## **PLAN REVIEW SHEET**

2017-076

Laurel Street Residential, LLC

Bus shelter pad detail

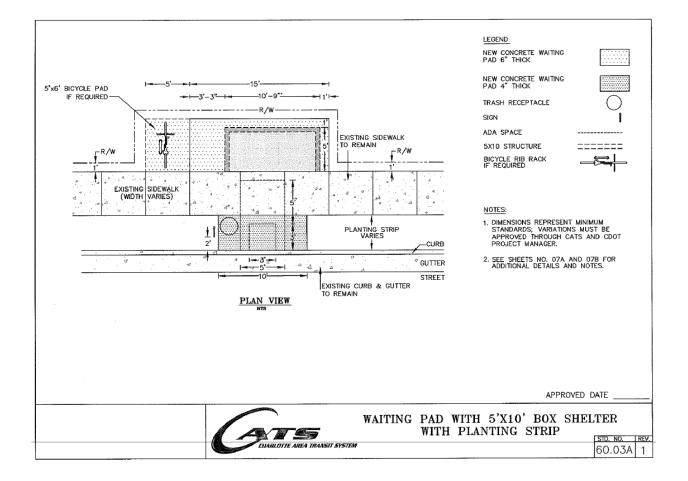
The Petitioner is requested to provide and construct a new shelter pad for the existing bus stop on West Tyvola Road along this site's frontage.

Below is an image of the standard detail (60.03A) for the requested bus shelter pad. Permanent easement is requested, where dimensions exceed existing or proposed right-of-way limits.
